Addendum / Addenda

Project Description / Description de projet		
M58 Abatement Ground Floor South		
Solicitation No./N° de sollicitation	Project No./N° de projet	W.O. No./N° d'ordre de travail
15-22093	5083	A1-006947-04-01
Departmental Representative / représentant ministériel		Date
Mark O'Connor		October 7, 2015
Notice:		Nota:
This addendum shall form part of the tender documents and all conditions shall apply and be read in conjunction with the original plans and specifications.		Cet addenda fait partie intégrale des dossiers d'appel; toutes les conditions énoncées doivent être lues et appliquées en conjonction avec les plans et les devis originaux.

project **M-58 HAZARDOUS MATERIAL ABATEMENT** projet
GROUND FLOOR, SOUTH WING

drawing **SCALE PLAN FOR ADDENDUM #1** dessin
 WHEN PRINTED TO SIZE INDICATED AT
 BOTTOM LEFT OF DRAWING

FIRST FLOOR PLAN
Scale: 1/4"=1'-0"
Top of steel at El. 321'-6" unless otherwise noted.
Note: All beam connections marked thus (B) to have 3/8" x 3/4" L top & bottom flange connections to columns in addition to shear connection.
For details of beam to column moment connections see Dwg. 529.

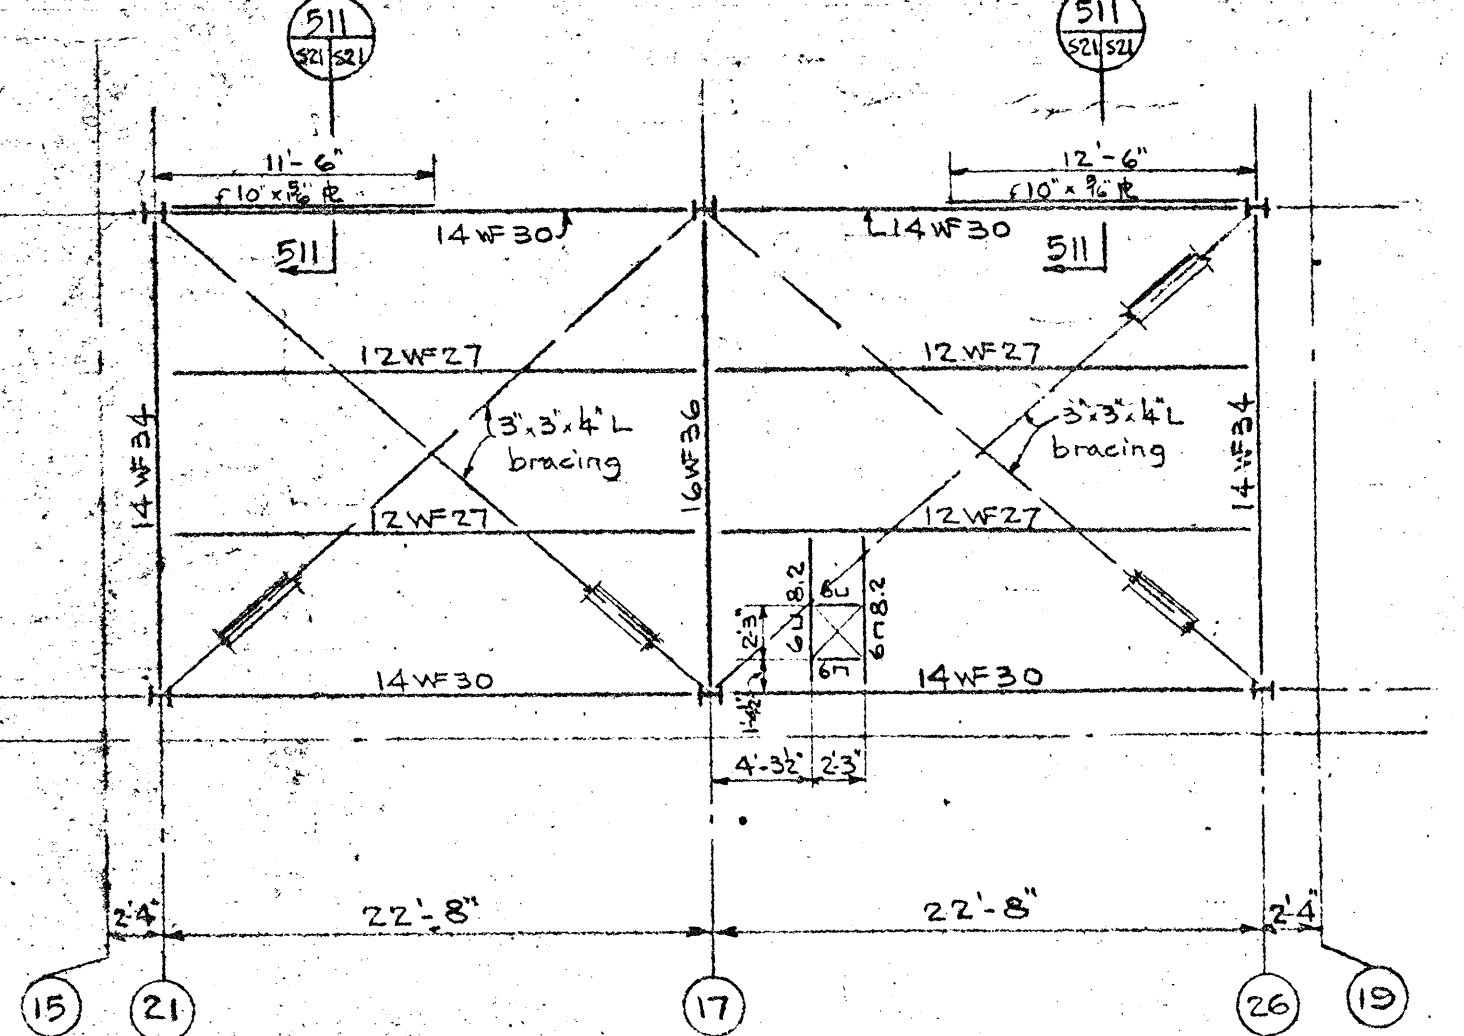
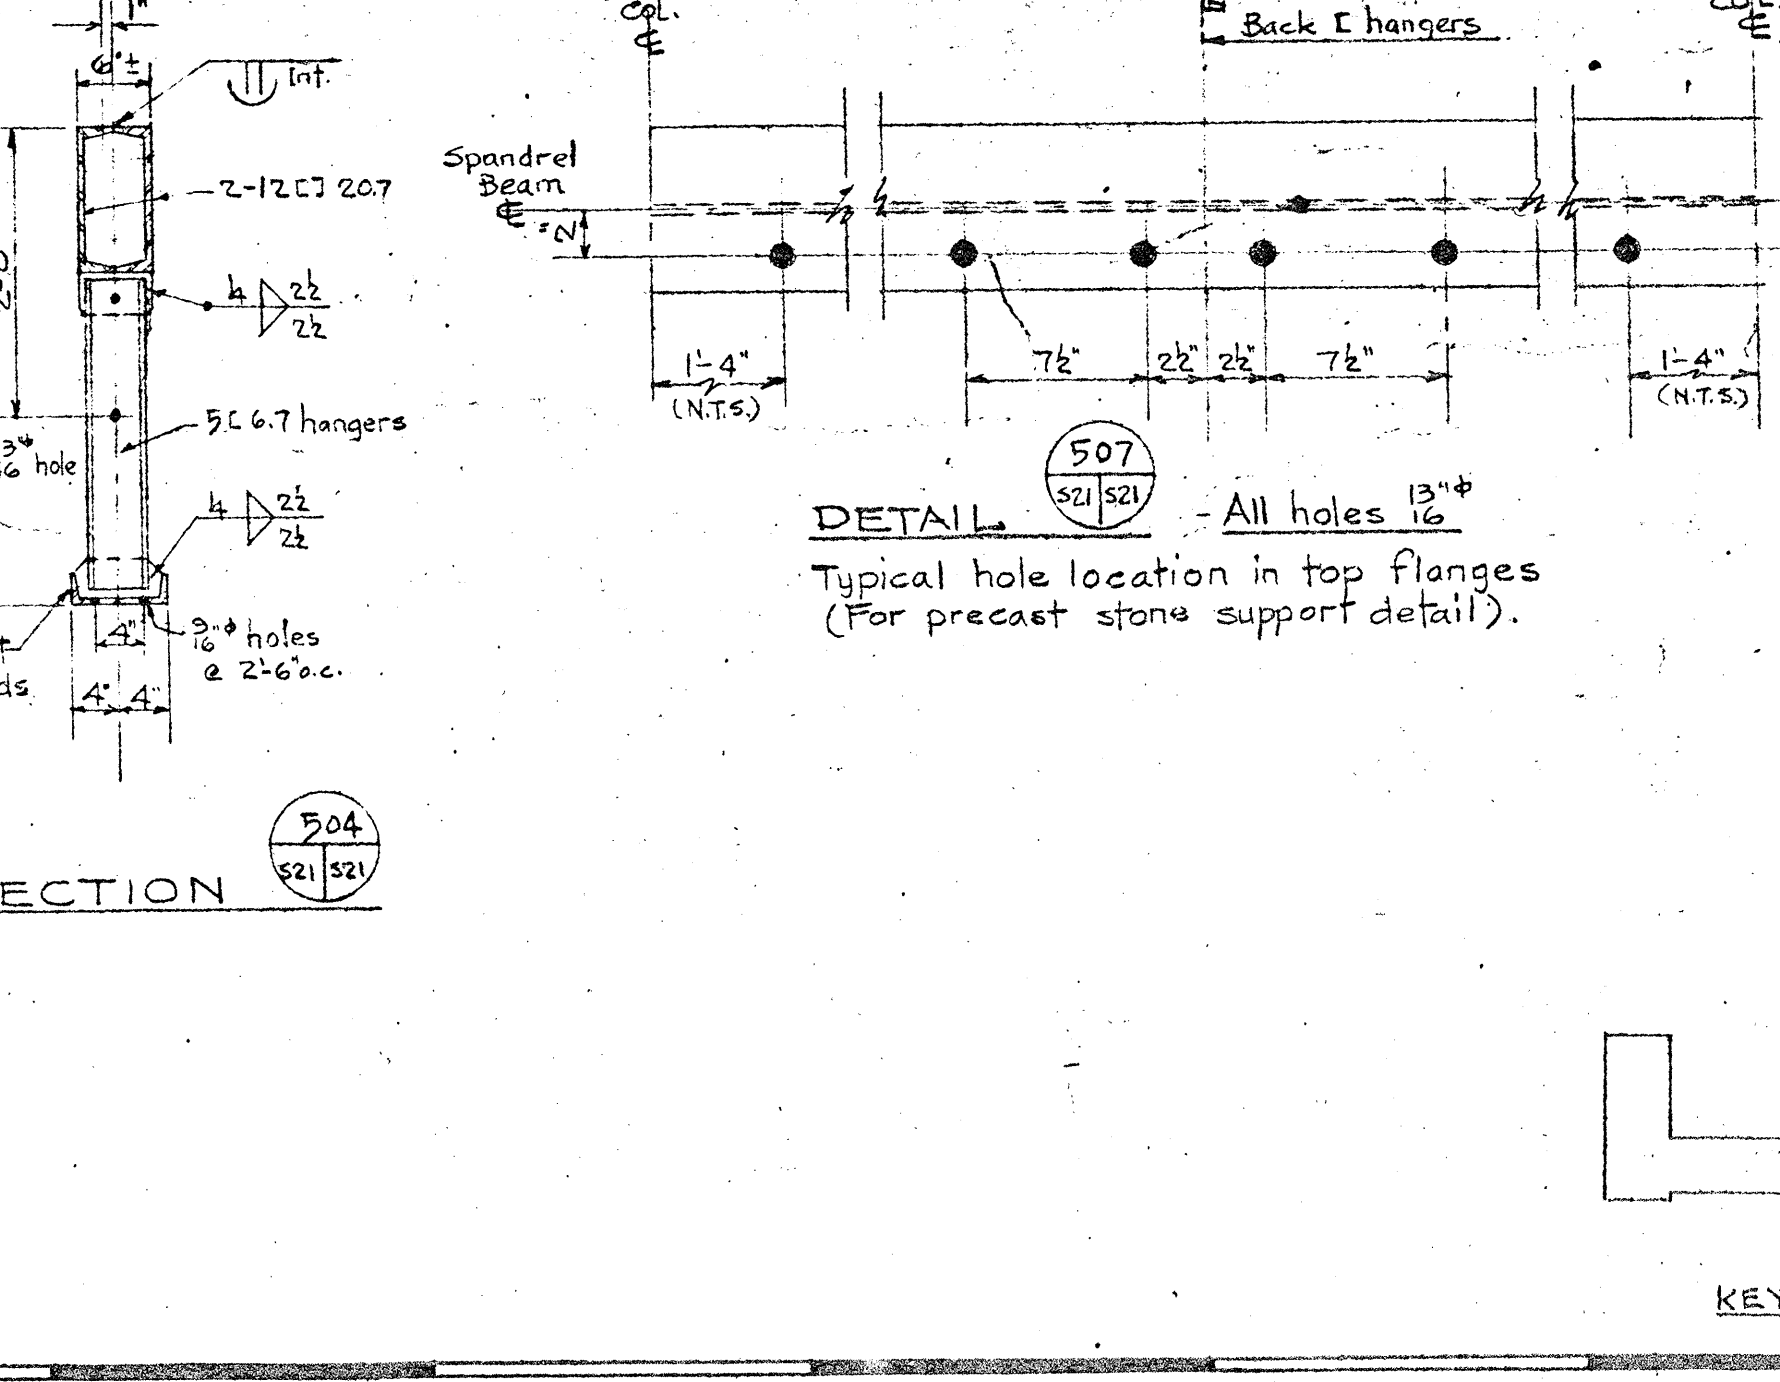
- 1 Steel drawings attached for reference. Drawing #S21
- 2 Scale architectural drawing attached for reference. Dated Oct 6 2015. Pipe chase noted on drawing that contractor must open to allow for abatement.
